Amendments to the Drawings:

REMARKS

Fig. 1A

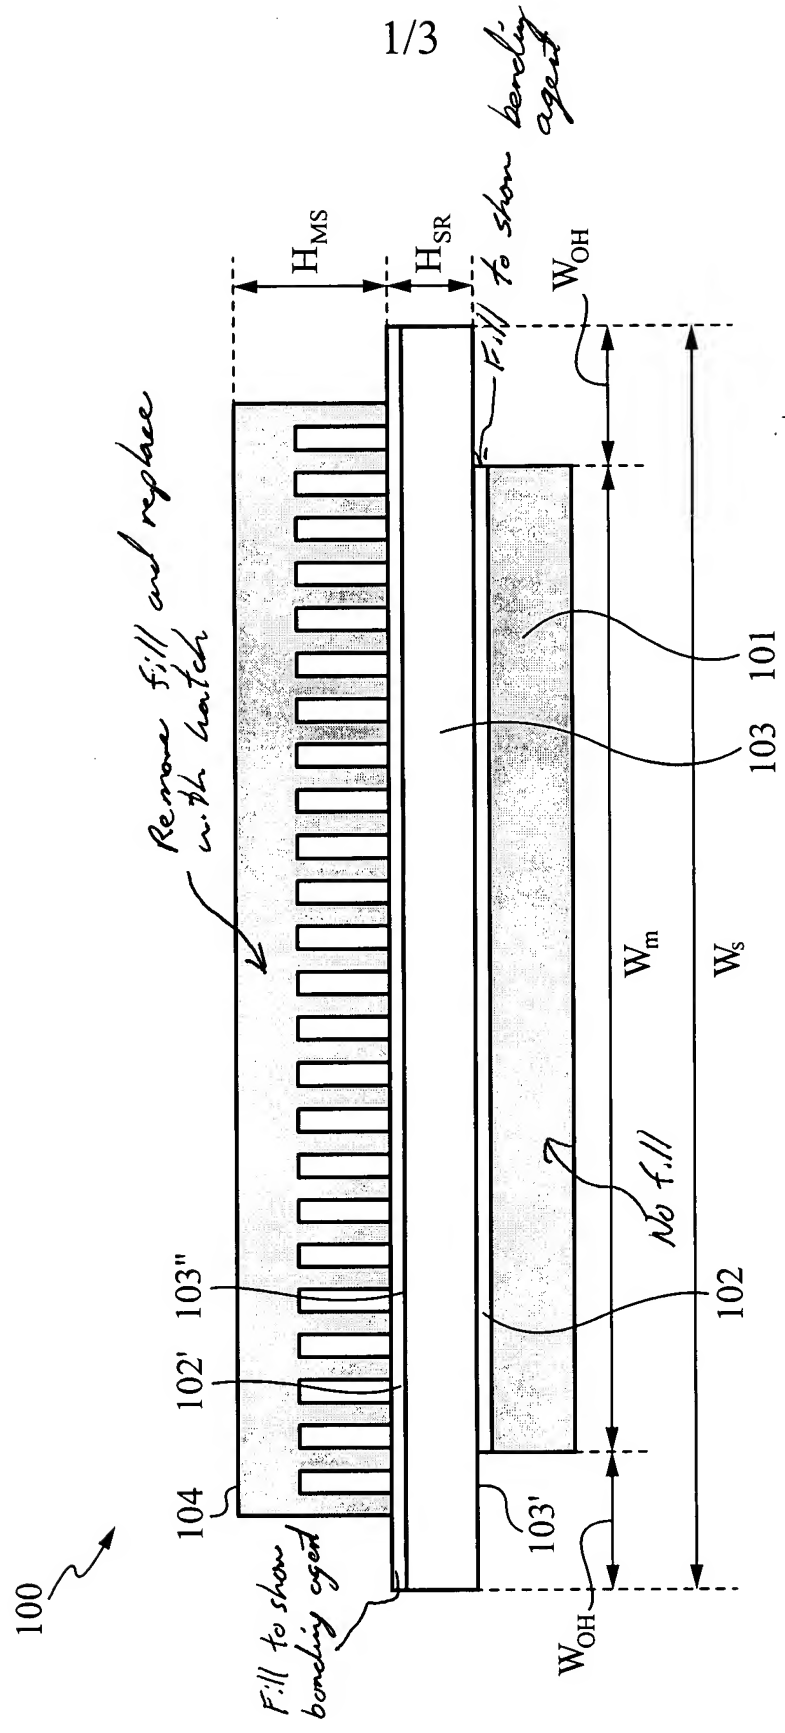
In Figure 1A, the gray shading of element 101 and 104 is replaced with crosshatching, the element of 103 is filled with crosshatching, and the bonding elements 102 and 102' is filed with the fill pattern for an adhesive or other bonding material.

The drawings have been objected to because they contain unevenly/improperly shaded areas (elements 101 and 104 in Figure 1A; elements 201 and 204 in Figure 2; elements 302 and 303 in Figure 3A; elements 301 and 302 in Figure 3B). By way of the annotated and replacement drawings, the drawings are now in compliance and the submitted replacement sheets and annotated sheets are in compliance with 37 C.F.R. 1.121(d).

Fig. 1B

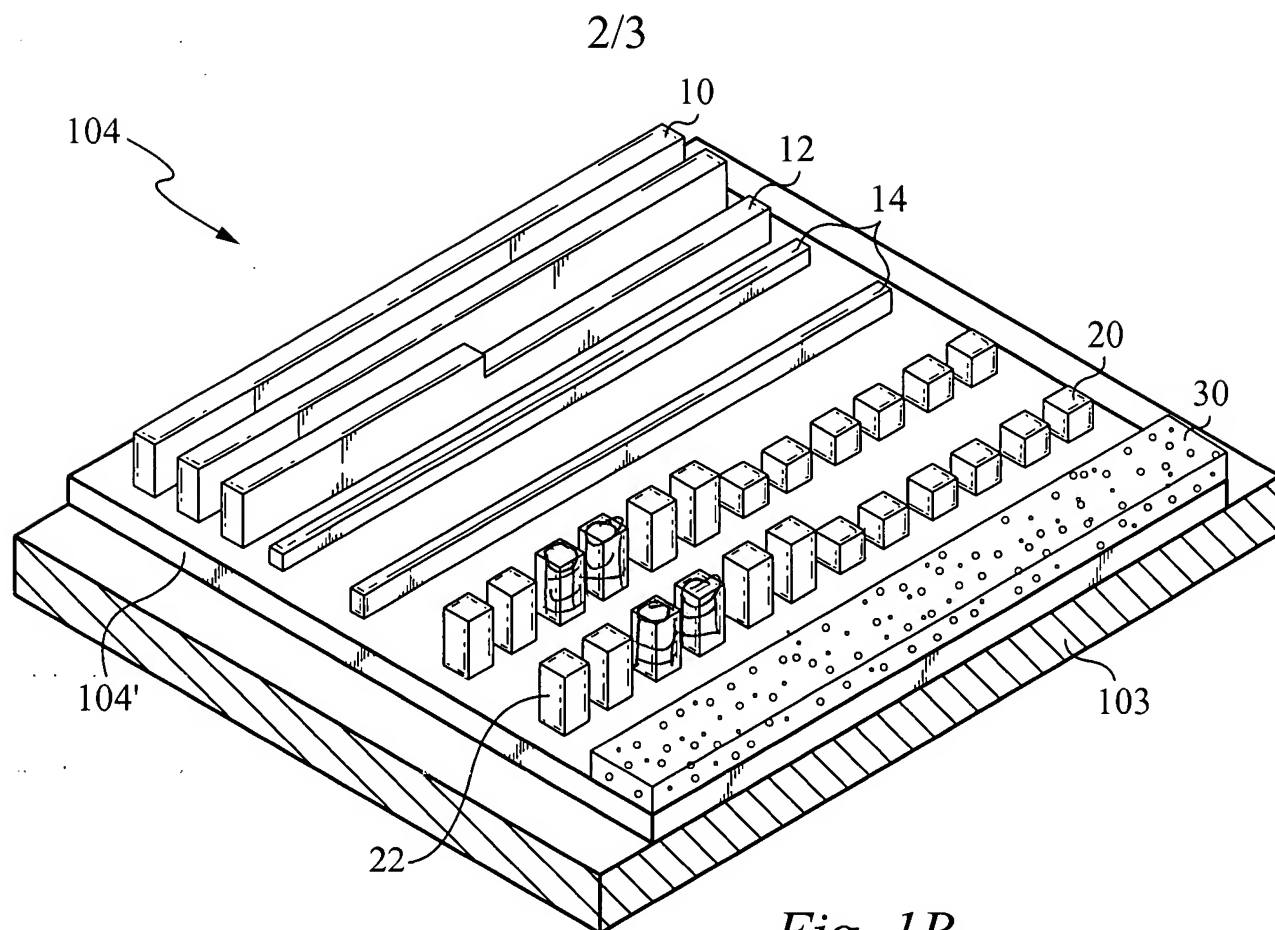
In Figure 1B, the micro pillars shown a element 22 is modified to show a micro pillar in the shape of a micro-pin.

The micropillars as called out in Claims 13, 17, 60 through 64 are disclosed in replacement sheet 2, Figure 1B, elements 20 and 22. These elements are supported in the specification on page 9, lines 5-13.

The micropillars comprising a plurality of pins as called out in Claims 14-16, 61-63, and 106-108 are disclosed in replacement sheet 2, Figure 1B, element 20. These elements are supported in the specification on page 9, lines 13-14.

Fig. 2

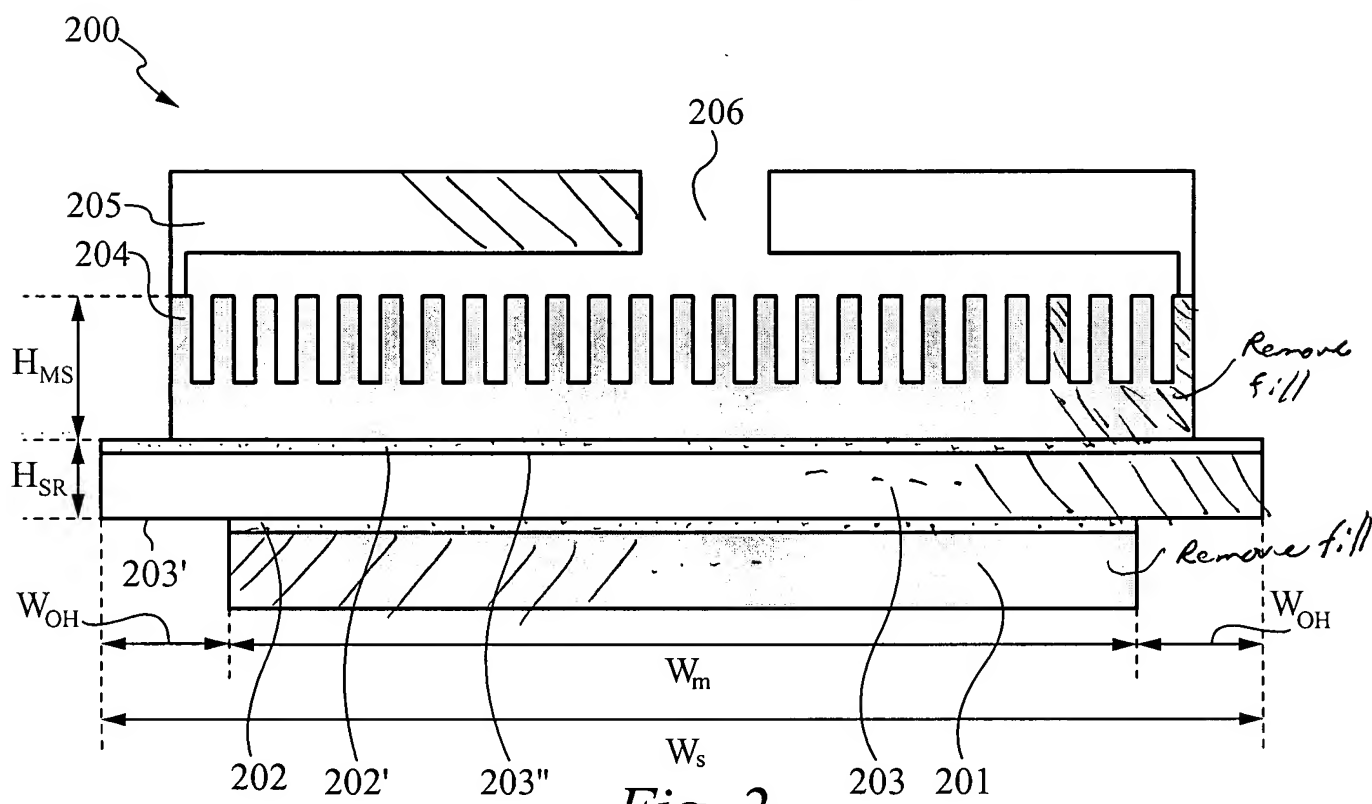
In Figure 2, the gray fill of 201 and 204 are replaced with a crosshatch pattern, the elements 203 and 205 are filled with crosshatch, and bonding elements 202 and 202' are filled with a fill pattern for an adhesive or other bonding material.
